- (A) Servicing Instruction/Hunter/84 A.B
Aileron Nose Balance Assembly : Loose
- (B) 1. Hunter Mk.4, 6, 7, 8, 9, 10 and 11 aircraft.
2. Ailerons port and starboard held as spare or in Stores." attached to the nose of the

AILERONS - NOSE BALANCE ASSEMBLY LOOSE.

S.I. / HUNTER / 84

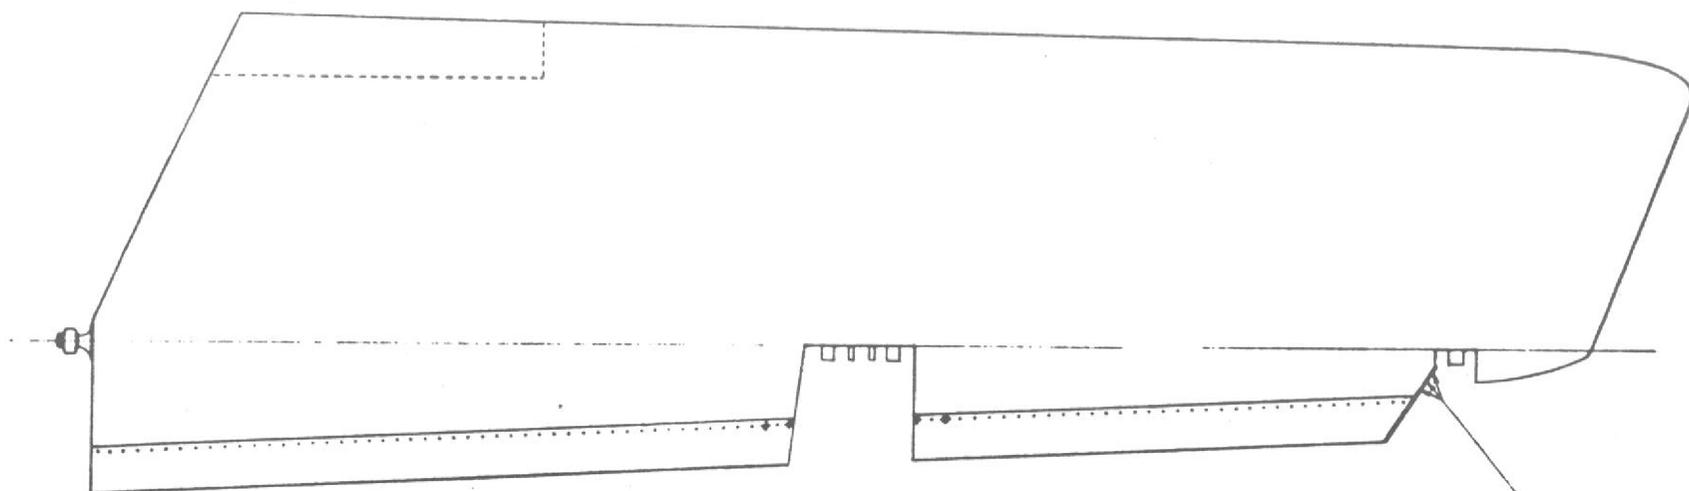
3 RIVETS IN SEALING ANGLE TO BE AGS 2050/424.

NOTE: THESE 3 HOLES ARE TO REMAIN $\frac{1}{8}$ " DIA.

RIVETS INDICATED THIS + TO BE AGS 2050/530. (4 OFF PER WEIGHT).

ALL OTHER SKIN RIVETS TO BE AGS 2050/524.

RIVETS IN END TABS TO BE AGS 2051/624. (DO NOT RE-COUNTERSINK HOLES)

NOTE: WITH AILERON STOOD ON EDGE, NOSE DOWN, THE HEADS OF THE RIVET HANDRELS SHOULD BE DRIVEN INTO THE AILERON AND RETAINED BY MEANS OF CALLOSEAL (REF. NO. 33H/264) PREVIOUSLY APPLIED TO THE REAR FACE OF THE LEAD WRAPPS AND RIVET HEADS.
